**Federal Aviation  
Administration**

# **Optimization of Airspace and Procedures in the Metroplex (OAPM)**

## **Design Submission Executive Summary North Texas Metroplex**

Name of Change and Airport/s	Date
AKUNA, BLECO, GRABE and LOWGN–DFW	22 August 2013
Change Classification	Current Phase of Design
Terminal Procedure SID	<input type="checkbox"/> Preliminary Design (PD) <input type="checkbox"/> Operational Design (OD) <input type="checkbox"/> Operational Design Complete (ODC) <input type="checkbox"/> Proposed Final Design (PFD) <input checked="" type="checkbox"/> Final Design (FD)
OAPM Study Team Reference(s)	Publication Date
Solution 11	29 May 2014
Affected Airport(s), Facilities and Positions, Areas, and/or Sectors	Facility Points of Contact
<b>Fort Worth ARTCC (ZFW)</b> <ul style="list-style-type: none"> <li>• Sector 53</li> </ul> <b>Dallas Fort-Worth TRACON (D10)</b> <ul style="list-style-type: none"> <li>• Sectors AR7, DN, DR1, DR2, DR3, DS, MN and MNH</li> </ul>	<b>ZFW</b> <ul style="list-style-type: none"> <li>• Robert Ellis</li> <li>• Jon Shedden</li> </ul> <b>D10</b> <ul style="list-style-type: none"> <li>• James Harlan</li> <li>• Ed Rivas</li> </ul>

**Figure 1. Proposed ARDIA FIVE RNAV SID**

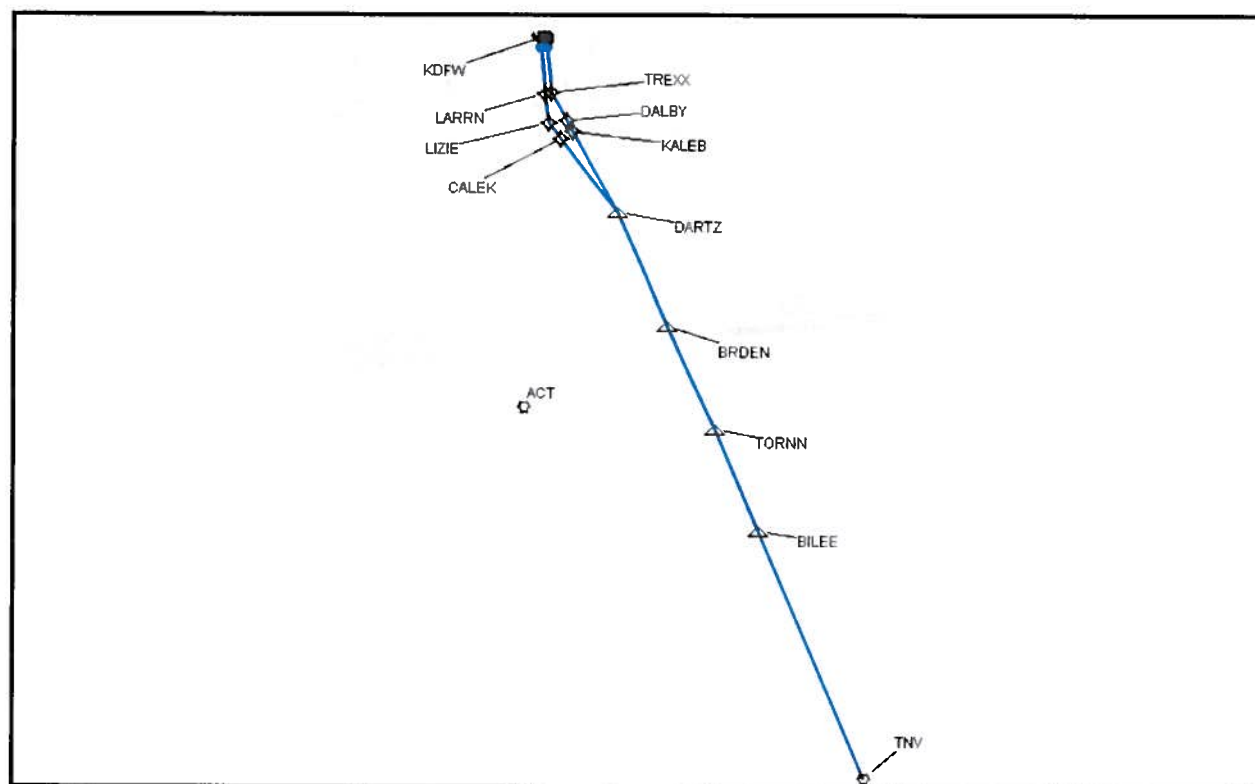
The Design Team opted to modify the ARDIA FOUR RNAV SID by adding the CUTSO waypoint for runways 18 L/R with an altitude restriction of at or above 10,000 feet to provide procedural de-confliction from the BACHR RNAV STAR. The NEAPS waypoint was added for runways 17 C/R with an altitude restriction of at or above 10,000 feet to provide procedural de-confliction from the BACHR RNAV STAR. The new procedure will be the ARDIA FIVE RNAV SID.

Figure 1 depicts the proposed ARDIA FIVE RNAV SID.

Figure 4. Proposed TRYTN RNAV SID and TRISS SID

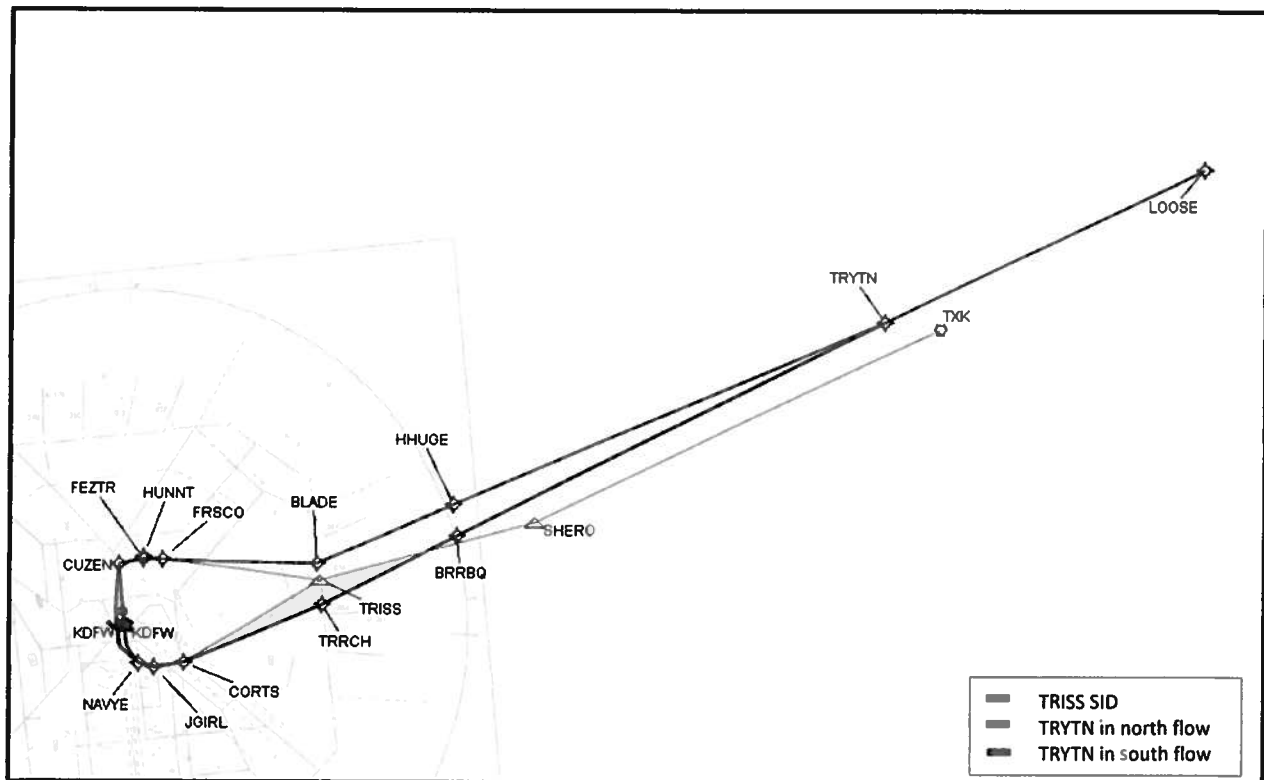
The Design Team kept the south flow routing to TRYTN waypoint identical to the routing proposed by the Study Team in Alternative 2. On the north flow, the Design Team amended the routing from CUZEN to BLADE waypoint to shorten the distance to the D10/ZFW boundary fix (by 0.87 NM). The remaining route to TRYTN is identical to the routing proposed by the Study Team in Alternative 2. An altitude restriction at FEZTR at or above 7,000 feet was added for procedural de-confliction from north bound DAL RNAV SIDs. The Design Team extended the routing from TRYTN to LOOSE waypoint. This will allow for a more direct routing for traffic routed over TXK.

Figure 4 depicts the proposed TRYTN RNAV SID.

**Figure 4. Proposed EMMTT and LNDRE RNAV SIDs and DAL SID**

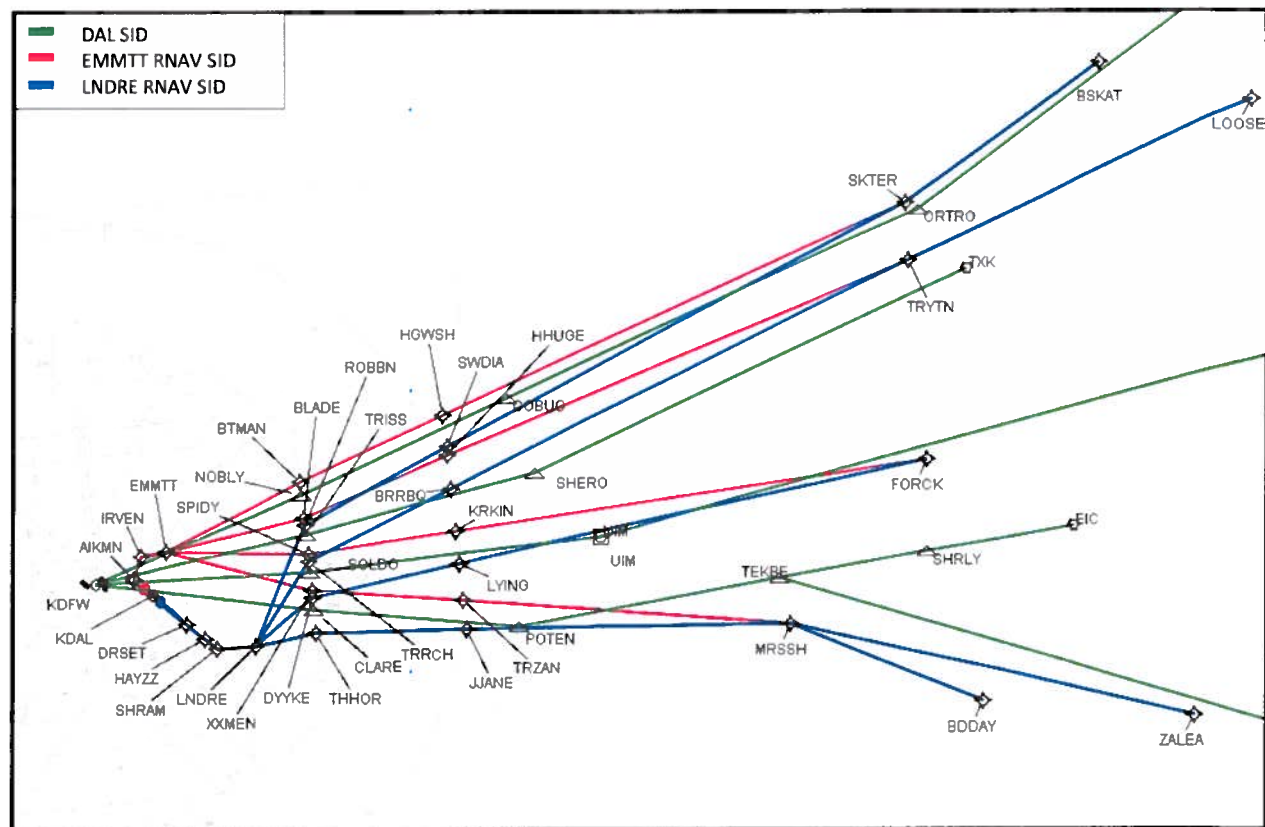
The Design Team tied these proposed procedures to the same boundary fixes the proposed DFW RNAV SIDs will use to increase flight path predictability and reduce controller task complexity. In the enroute environment, per coordination with the ZHU the BDDAY transition will be ATC assigned only. These designs are slightly modified from the Study Team recommendation to provide for longitudinal de-confliction from the east bound DFW RNAV SIDs in a north flow.

Figure 4 depicts the proposed EMMTT and LNDRE RNAV SIDs.

**Figure 4. Proposed KKITY and SNET RNAV SIDs and WORTH SID**

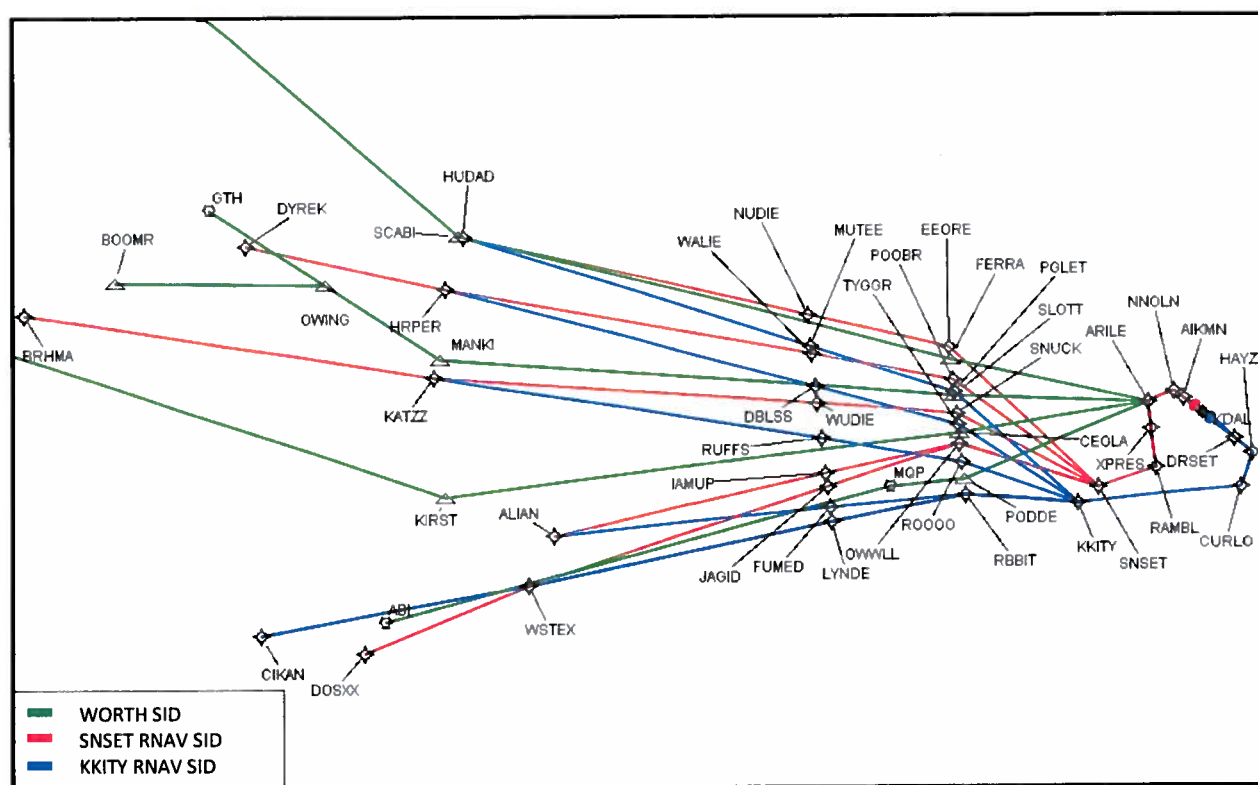
Figure 4 depicts the proposed SNET and KKITY RNAV SIDs.

**Figure 1. Proposed SWABR RNAV SID and WORTH SID**

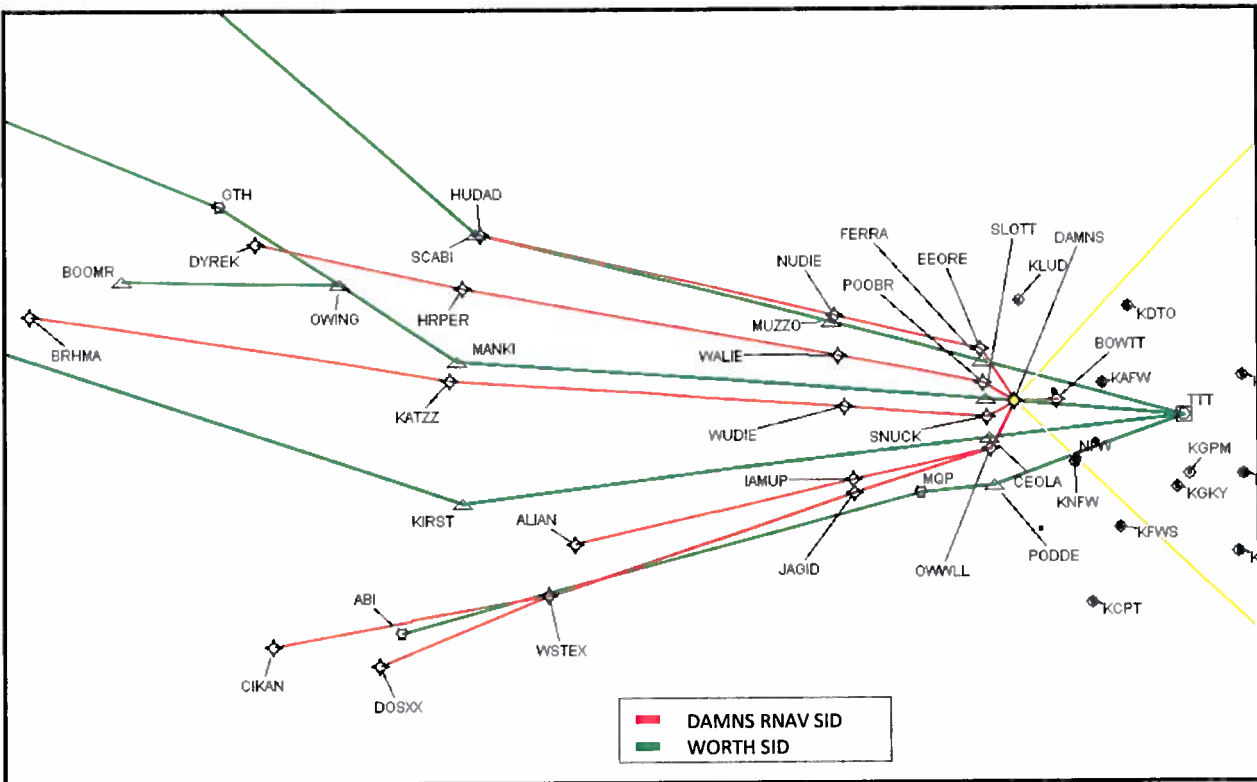
Figure 1 depicts the proposed SWABR RNAV SID.

**Figure 1. Proposed KUSSO RNAV SID and WYLIE SID**

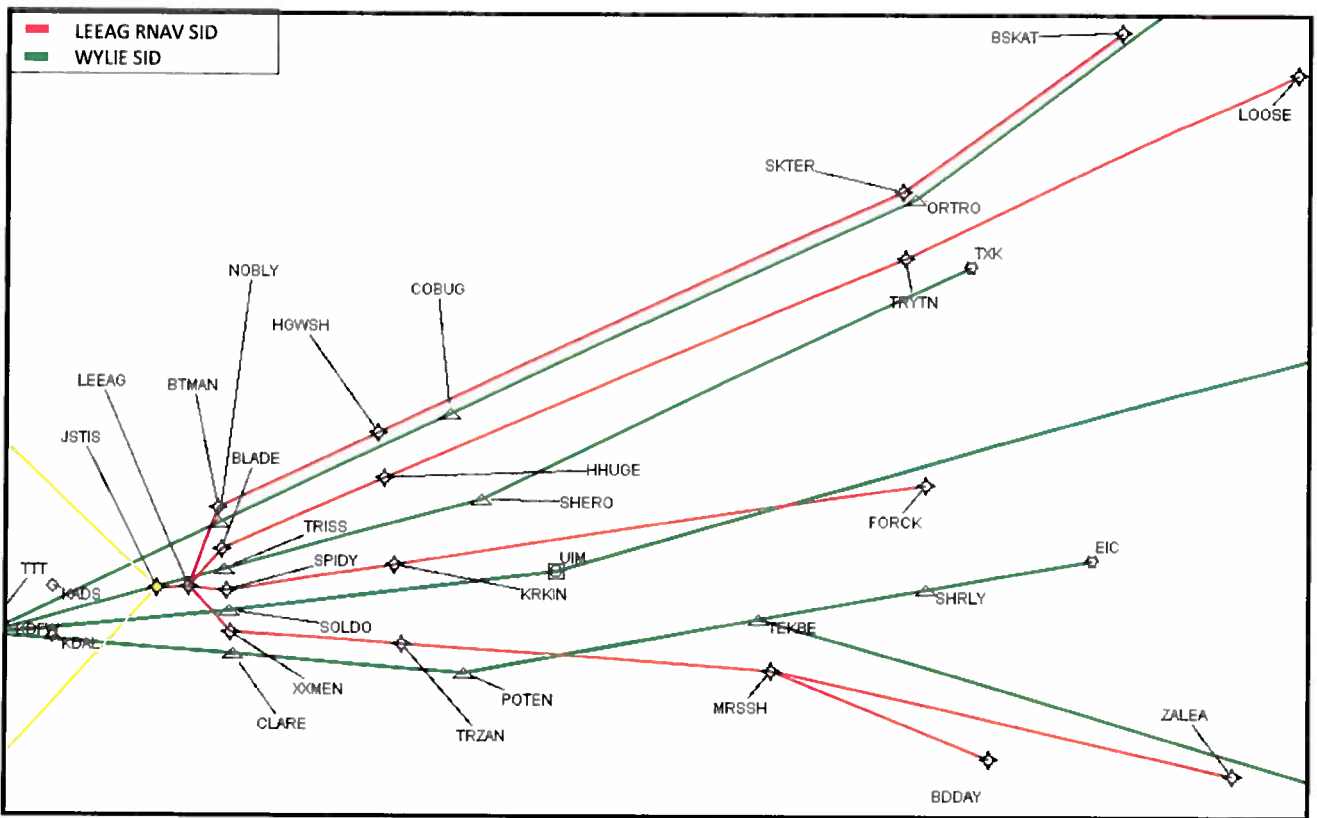
The Design Team created a radar vector RNAV SID for all D10 Satellite airports in a north and south flow. According to the rules governing RNAV SIDs, a radar vector RNAV SID must have an initial common fix, LEGIN and JSTIS waypoints, followed by a common route to a transition fix, from which the four transition legs branch. Aircraft that are assigned this SID must be within a ninety degree “cone” west of the initial common fix before being allowed to proceed direct to it. If they don’t depart from an airport that lies within the cone they must be vectored into it. East bound turbojet aircraft departing from the western Satellite airports may be stacked above the DFW/DAL east bound departures, and east bound turbojet aircraft departing from the eastern Satellite airports may be stacked below the DFW/DAL departures. ZFW will have control for turns and climb.

Figure 1 depicts the proposed KUSSO RNAV SID.

**Figure 3. CAINE and DAWGZ RNAV STARs**

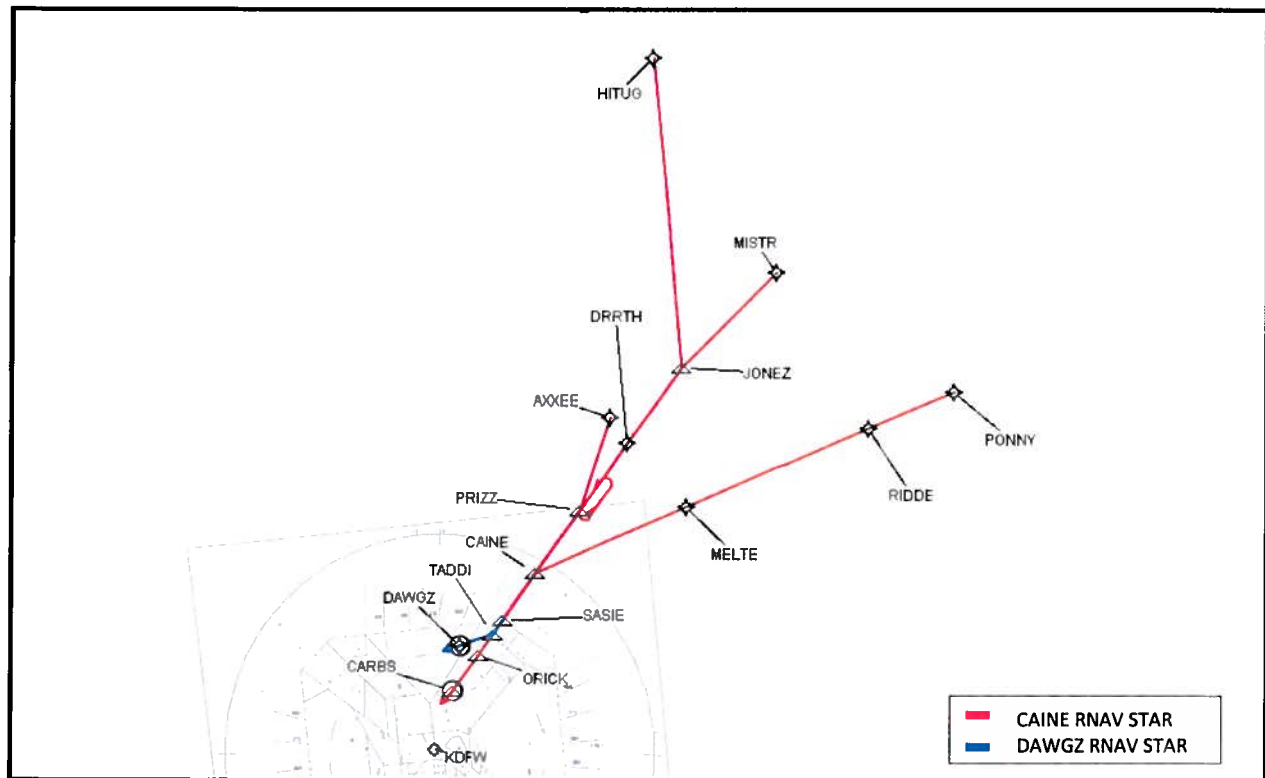
The North Texas OAPM Design Team is proposing the creation of two new RNAV STARs, named CAINE and DAWGZ to replace the JONEZ STAR. The proposed designs are slightly modified from the Study Team design by moving a transition to start at PONNY waypoint to align with the ZFW Sector 50 boundary and with the addition of enroute transitions at RIDDE and AXXEE waypoints. After crossing SASIE waypoint, north flow arrivals will transition to CARBS waypoint for the downwind, and in south flow DAWGZ waypoint for the base leg.

Figure 3 depicts the proposed CAINE and DAWGZ RNAV STARs.

**Figure 3. Proposed GIBBI and SHAAM RNAV STARS and MASTY STAR**

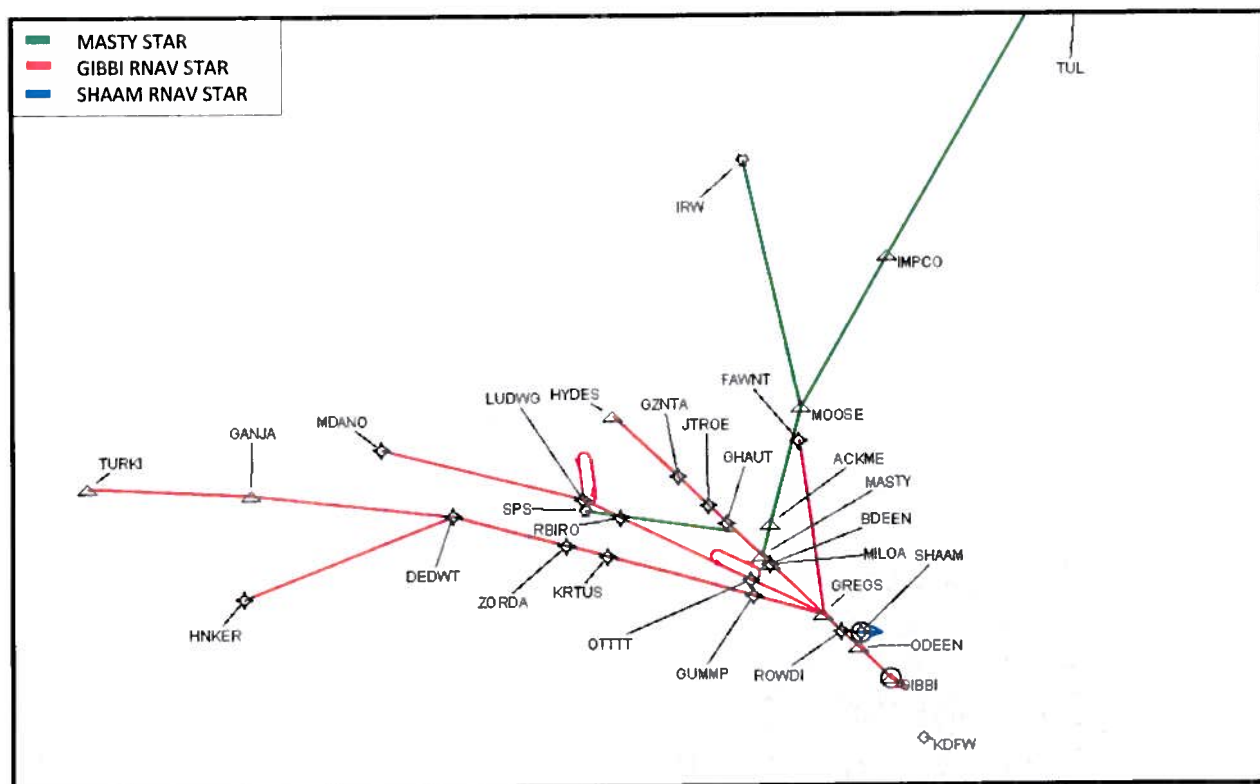
The North Texas Design Team is proposing the creation of two new RNAV STARs, named GIBBI and SHAAM to replace the MASTY STAR. The proposed designs are similar in design to the MASTY STAR, incorporating additional enroute transitions, merging at GREGS waypoint and incorporating a more direct route from the FAWNT and LUDWG waypoints. In south flow on the SHAAM RNAV STAR after GREGS aircraft will proceed to ROWDI waypoint before turning east on to the base leg. In north flow on the GIBBI RNAV STAR after GREGS aircraft will continue to GIBBI waypoint then expect vectors to the downwind. The addition of the enroute transitions will provide a more predictable routing for traffic arriving from ZAB.

Figure 3 depicts the proposed GIBBI and SHAAM RNAV STARS.

**Figure 3. Proposed BAWLZ and CABBYP RNAV STARs and JAGGO THREE STAR**

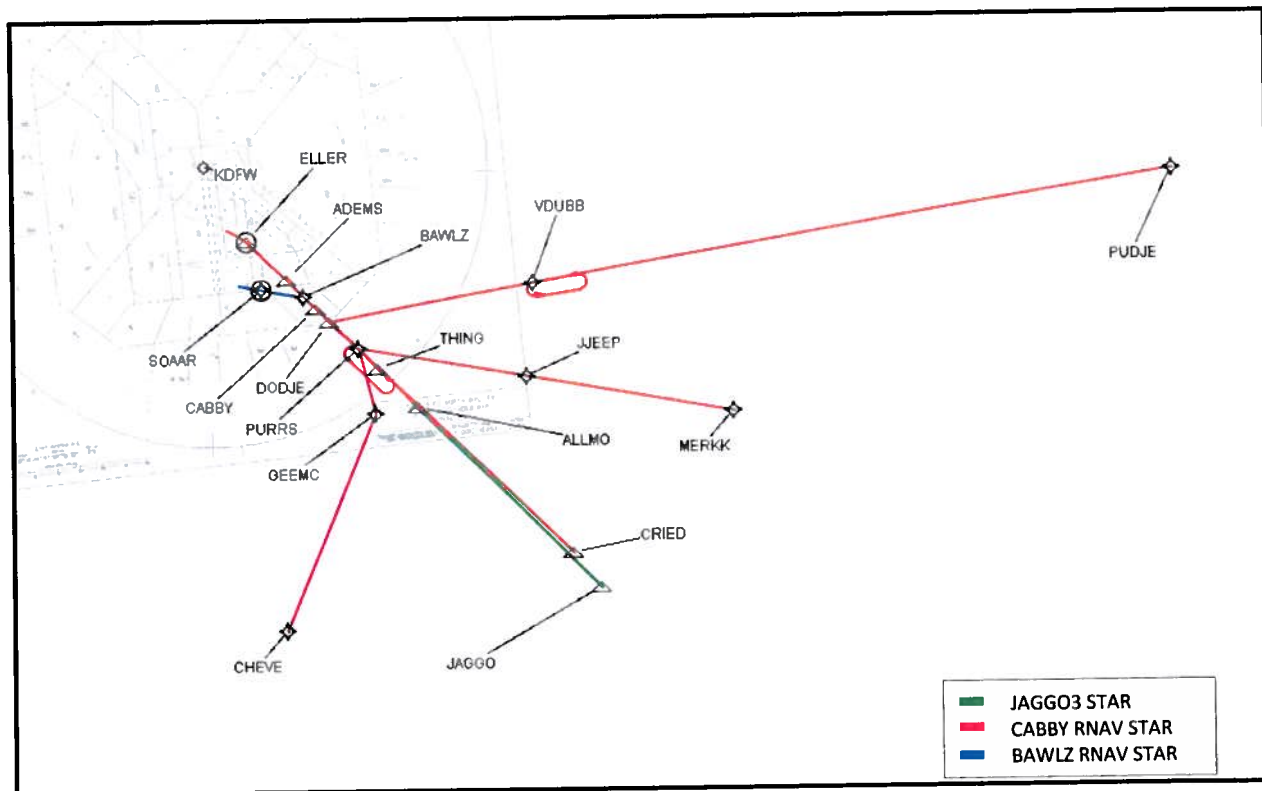
The North Texas OAPM Design Team is proposing the implementation of two new RNAV STARS named BAWLZ and CABBY for traffic offloaded from the KLNDR and WHINY RNAV STARS during times of high traffic volume. These procedures will be ATC-assigned only. These procedures will replace the JAGGO STAR. A total of four enroute transitions starting at PUDJE, MERKK, CRIED and CHEVE waypoints are incorporated into the RNAV STARS. The proposed procedure design is similar to the JAGGO STAR and procedurally de-conflicted from the proposed KLNDR and WHINY RNAV STARS. The Design Team did not include the crossover procedure to the west side of DFW as proposed by the Study Team. Industry partners suggested it would not be beneficial to publish this as the procedure is seldom

Figure 3 depicts the proposed BAWLZ and CABBYP RNAV STARs.
